Planning Commission Staff Report

Project Type: Site Development Section Plan

Location: Chesterfield Commons Seven, Lot 2

Description: **Chesterfield Commons Seven, Lot 2 (Valvoline)**: A Site Development Section Plan, Landscape Plan, Lighting Plan, Architectural Elevations, and Architect's Statement of Design for a 0.977 acre tract of land zoned "PC" Planned Commercial District located on the north side of Chesterfield Airport Road, one-half mile west of the corner of Chesterfield Airport Road and Boone's Crossing.

PLANTING PLAN FOR THE PROPOSED
Valvoline
CHESTERFIELD, MISSOURI

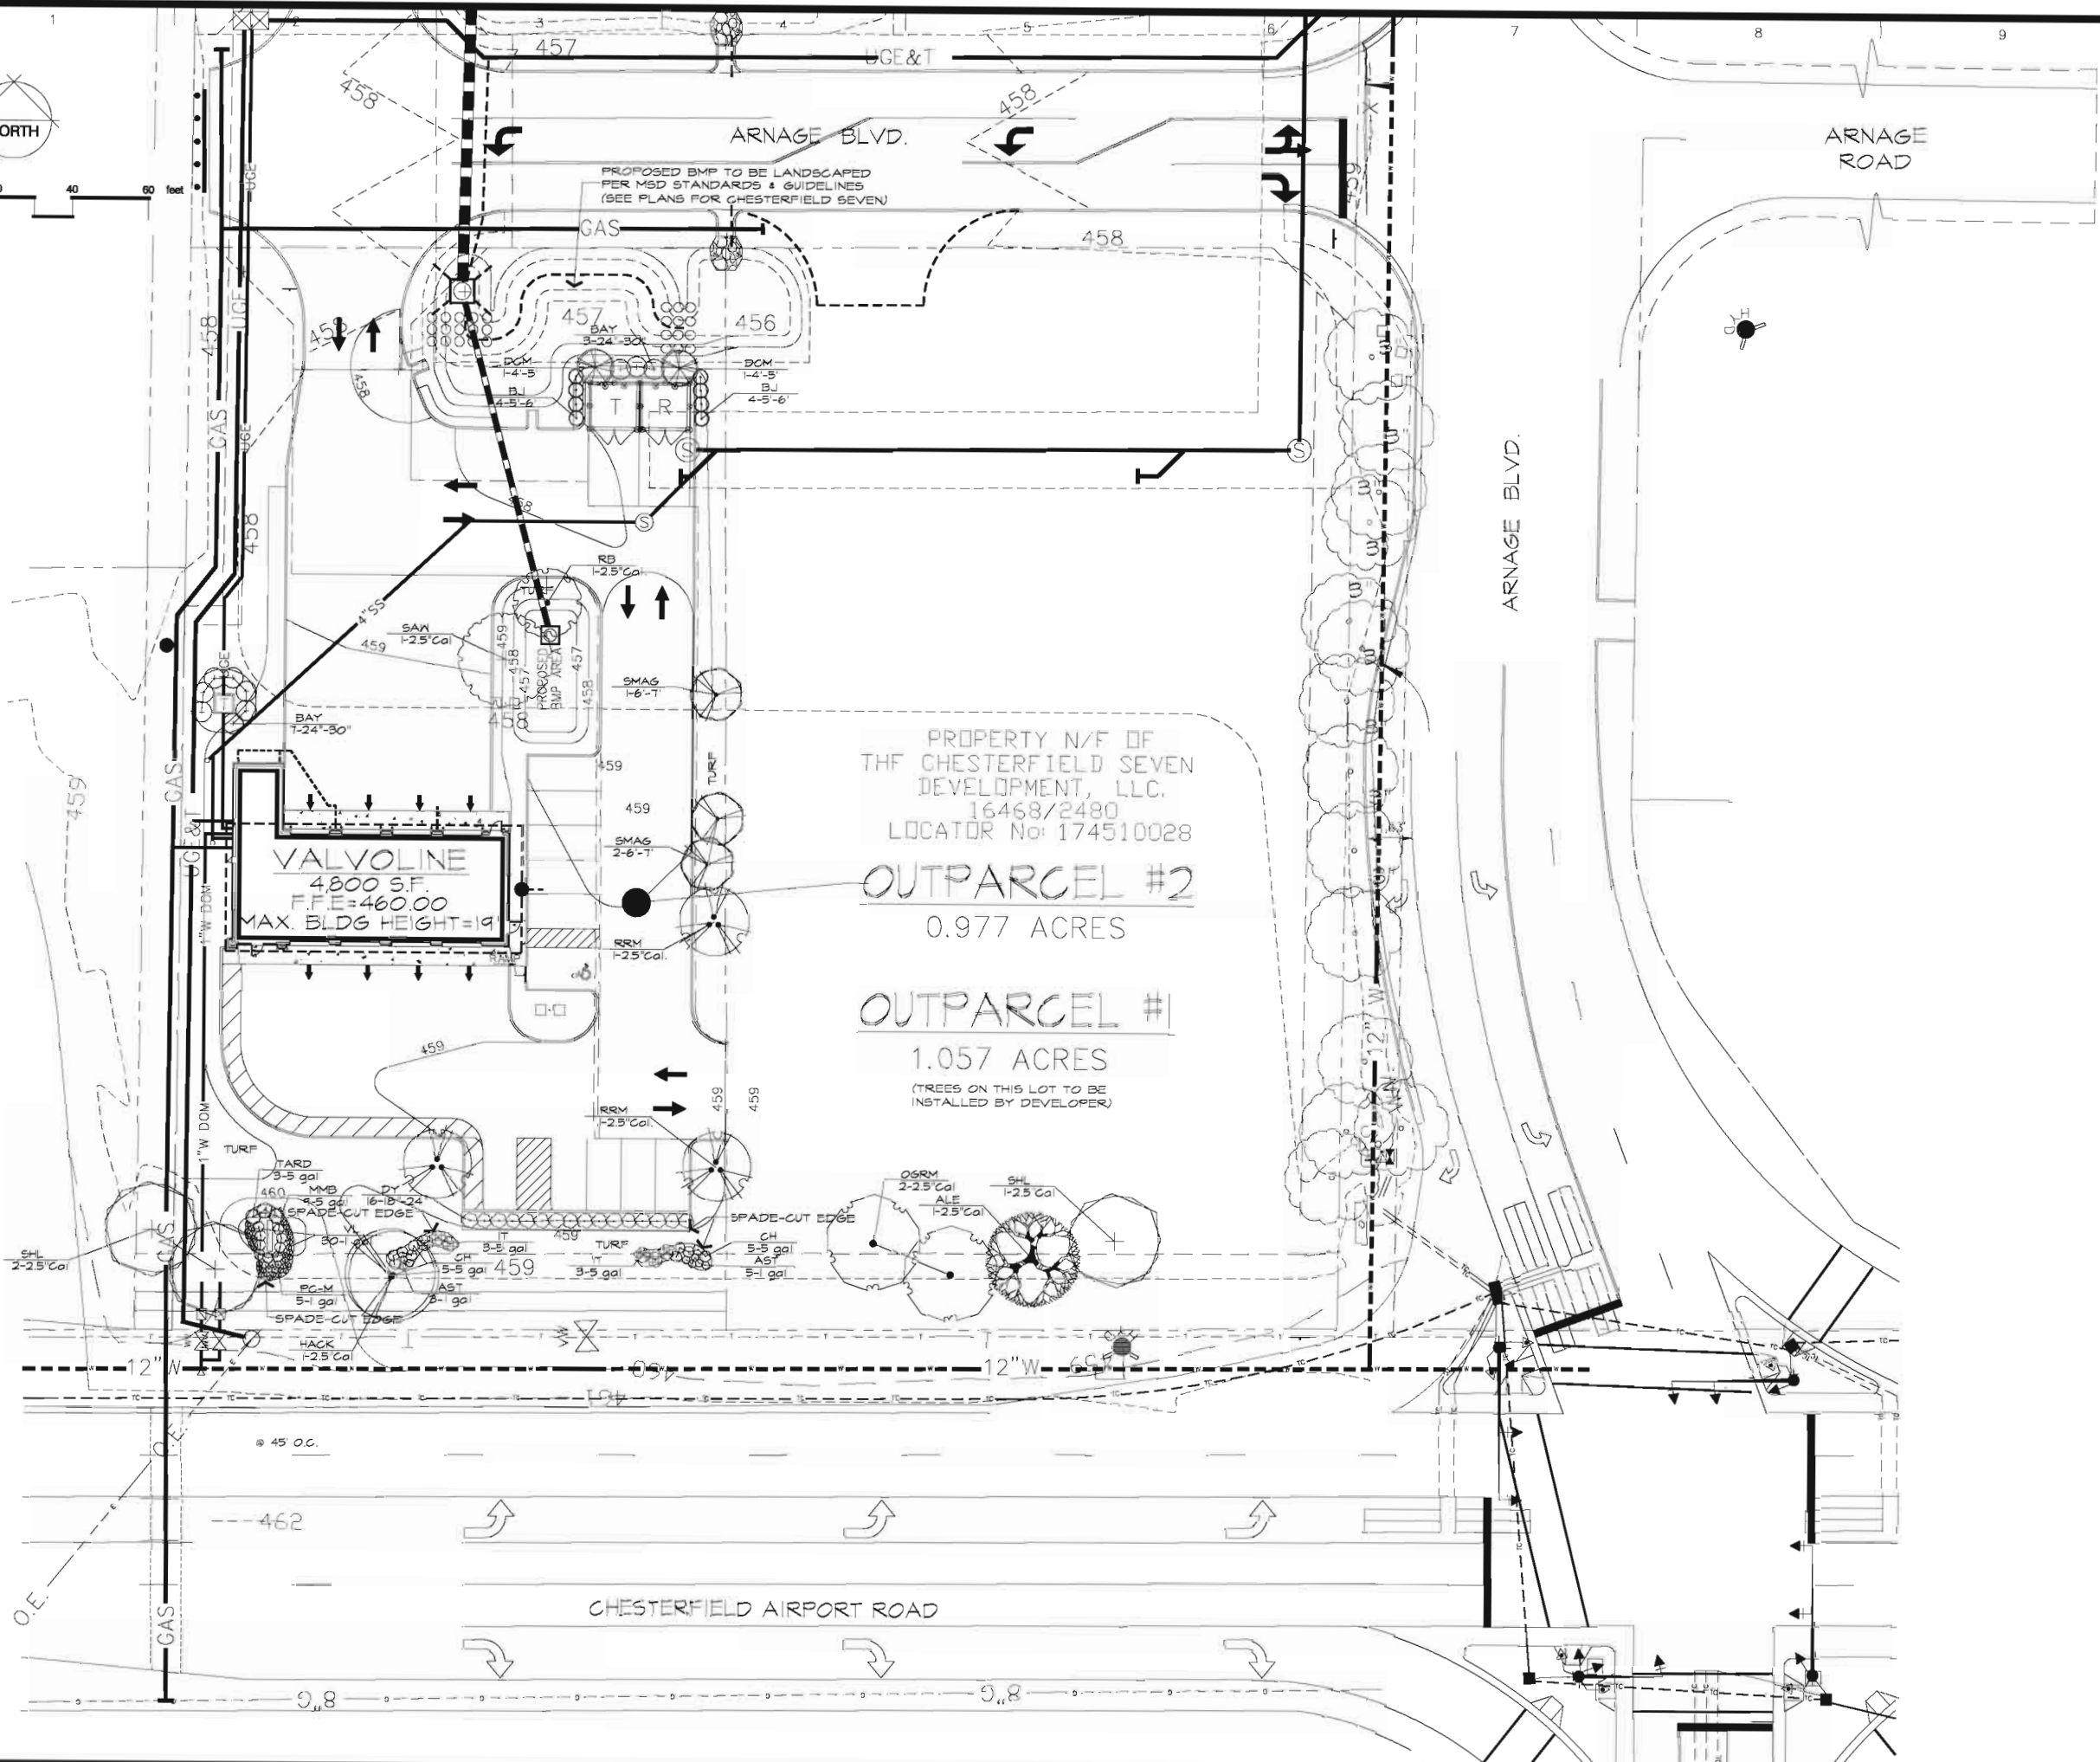
A Landscape Plan was submitted showing new trees and shrubs to be installed throughout the site. Water quality features are being provided per the requirements of the Metropolitan Sewer District and the proposed plantings were reviewed to ensure no sight distance issues existed.

The Landscape Plan meets all requirements of the City of Chesterfield Tree Preservation and Landscape Requirements. The City Arborist has reviewed the Landscape Plan and had no additional comments.
